# PRODUCT SHEET:

## RAMPTECH COPPER BRASS HIGH EFFICIENCY RADIATOR

Sage  
Part Number 825203

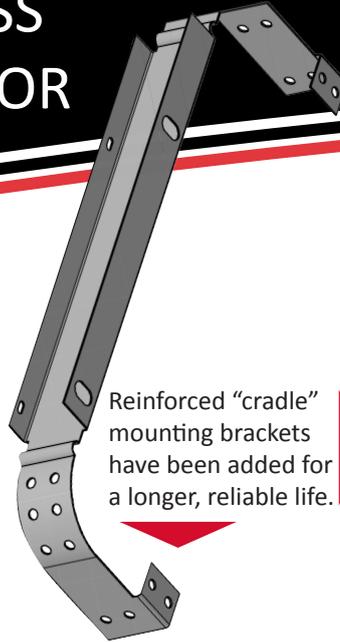
Reinforced "cradle" mounting brackets have been added for a longer, reliable life.

- ✓ Redesigned bracket configuration for a longer, reliable life
- ✓ Tank wall thickness increased by 25%
- ✓ Increase brazing material around all ports and filler neck

The filler neck is reinforced with internal and external brazing.

Transmission coolant ports have been improved by a 25% increase in tank wall thickness.

The inlet/outlet tubes have strengthened by securing two anchor points welded to both sides by an enhanced brazing process.
